COUNCIL ASSESSMENT REPORT

Panel Reference	PPSSEC-8
DA Number	DA2015/100/5
LGA	Strathfield Council
Proposed Development	Section 4.55(2) of the Environmental Planning & Assessment Act 1979 to surrender DA2017/168 and modifications to approved development including enlargement of basement level 3.
Street Address	86 Centenary Drive, Strathfield
Applicant/Owner	Joseph El Khawaja & : Builtcom Properties 5 Pty Ltd
Date of DA lodgement	25 July 2019
Number of Submissions	Six (6) submissions – four (4) objections and two (2) in support.
Recommendation	Approval
Regional Development Criteria (Schedule 7 of the SEPP (State and Regional Development) 2011	General development with a capital investment value of more than \$30 million
List of all relevant s4.15(1)(a) matters	<p>State Environmental Planning Policy No. 55 – Remediation of Land</p> <p>State Environmental Planning Policy (Building Sustainability Index: BASIX) 2004</p> <p>State Environmental Planning Policy (Infrastructure) 2007</p> <p>State Environmental Planning Policy (Vegetation in Non-Rural Areas) 2017</p> <p>State Environmental Planning Policy No 65 – Design Quality of Residential Apartment Development</p> <ul style="list-style-ty

Figure 6: Rooftop private open space area proposed for Building B

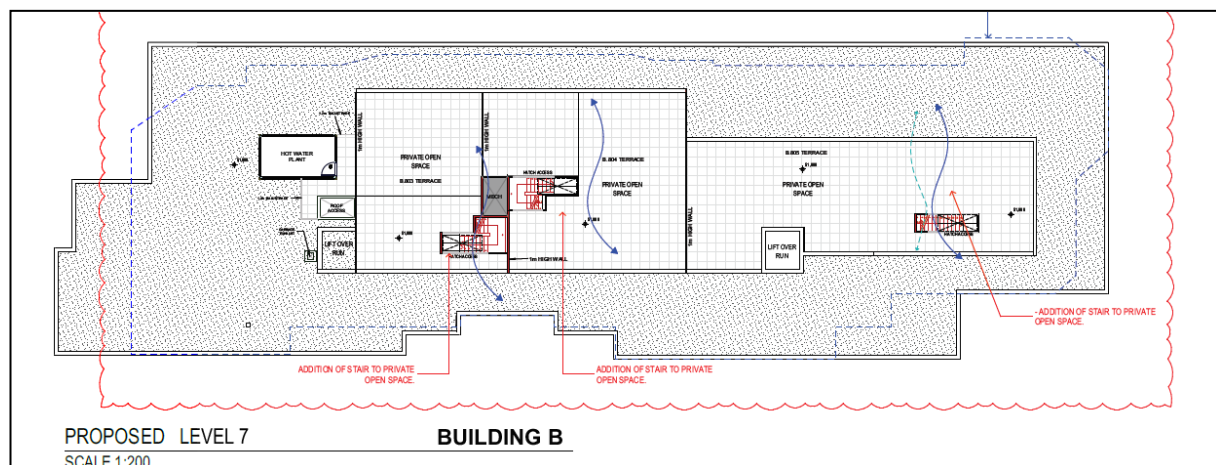
Comment: The proposal has sought the provision of roof top private open space areas on Building B which will be accessed via private stairwells from the corresponding units below. The proposal consequently involves the installation of 1m high fences upon the roof top area to provide separation between units. Accordingly, the 1m high walls create additional building height to the building. Whilst the 1m high walls fall within the maximum building height permitted for the site, the 1m high walls will not be adequate enough to enable an effective means of visual privacy between adjoining units. To achieve this, the building wall would need to be increased by a minimum 800mm to 1.8m. As each of the Level 7 units are provided with adequate private open space areas which comply with the minimum requirements of the ADG in terms of dimensions and solar access, the additional private open space areas on the roof top are not necessary.

Accordingly, a condition of consent is recommended to delete all roof top private open space areas and corresponding stairwells.

Figure 10: Proposed floor plan of kiosk with mechanical services and shading device overhead.

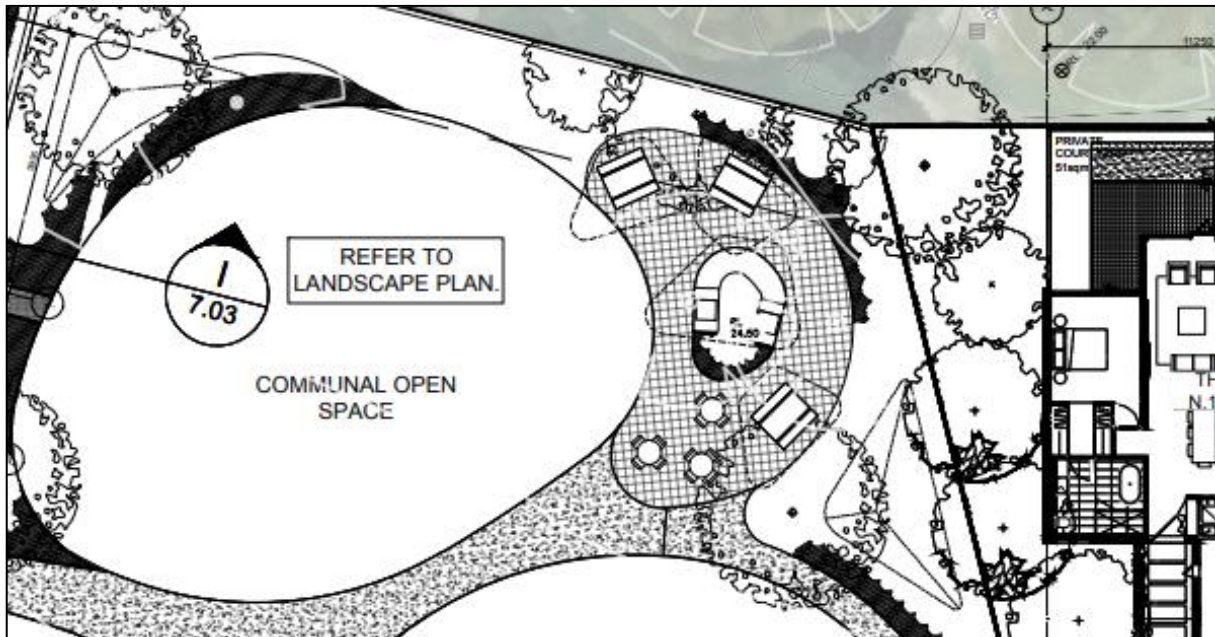
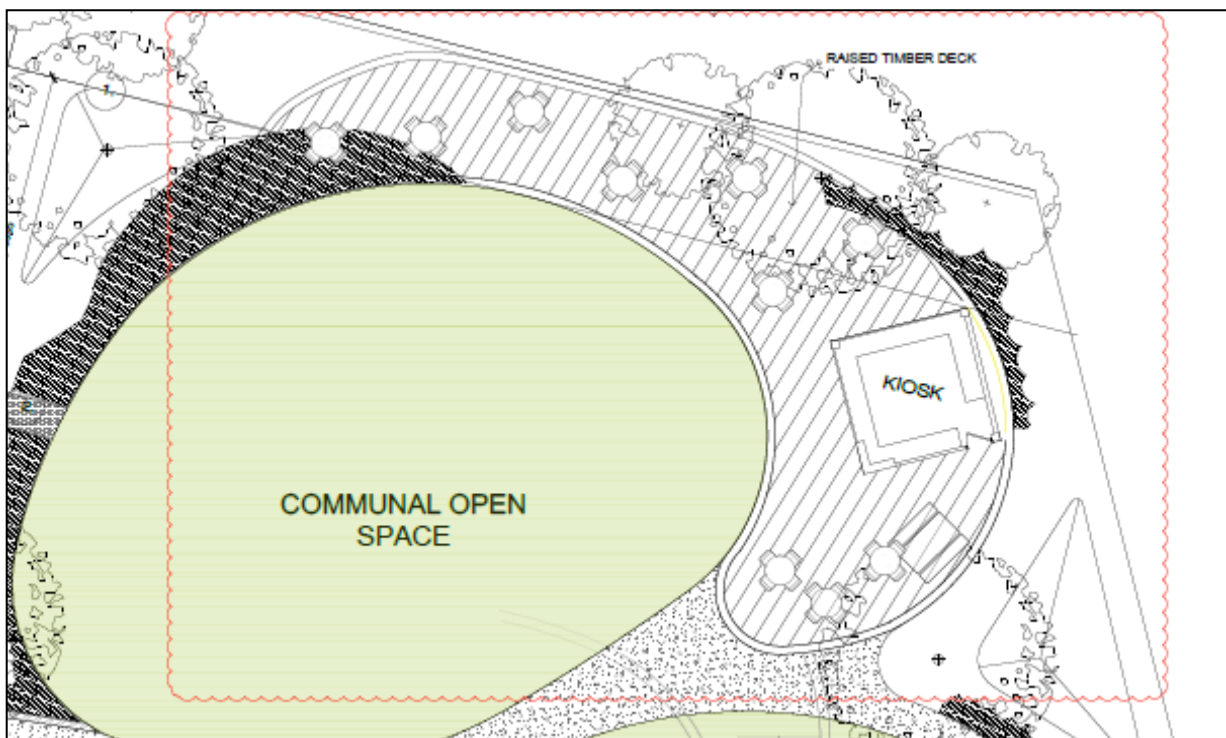
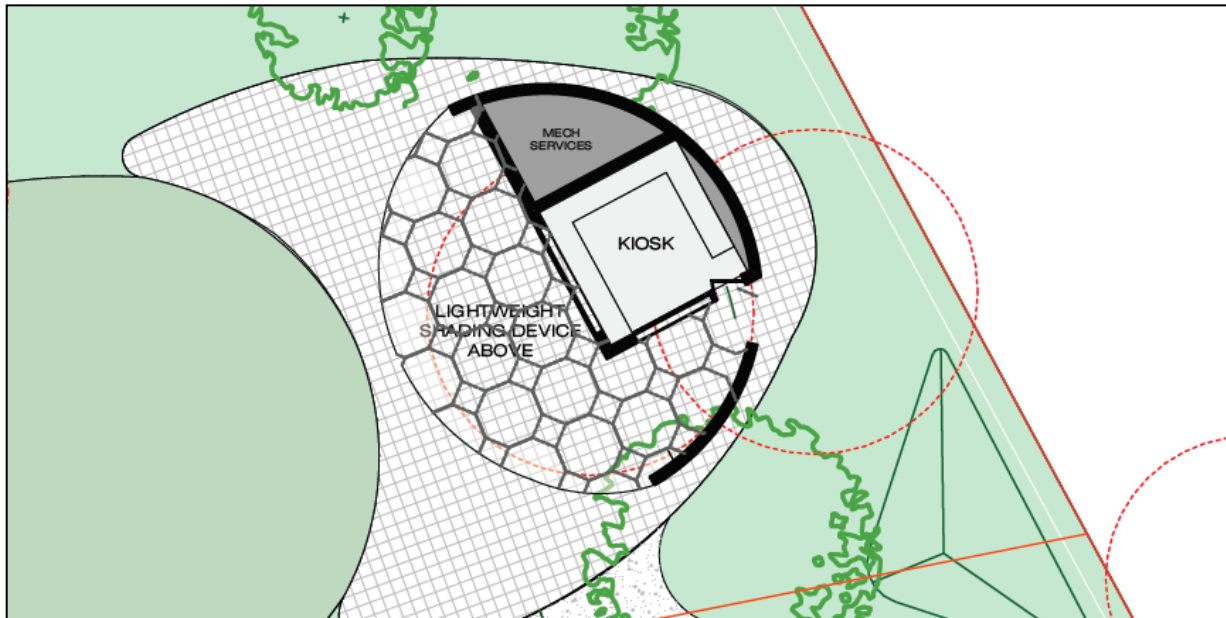
The application proposes modifications to the café kiosk on the eastern corner of the site (refer to Figure 8, 9 and 10). The kiosk would be located in the area where a pergola was approved under the original application.

Whilst the café is a permissible use in the B4 – Mixed Use zone, the proposed café kiosk introduces a new use which was not approved under the original application or the modified application notwithstanding its inclusion on the approved plans as modified by DA2015/100/03. Furthermore, the Section 4.55 application does not include the details of the kiosk such as the building elevations or details of operations (i.e. operating hours/days, staff etc).

Accordingly, the proposed construction and use of the café kiosk is not supported with this modification. A condition of consent has been recommended to delete the proposed kiosk and reinstate the kiosk structure with the pergola which was originally approved under the original application.
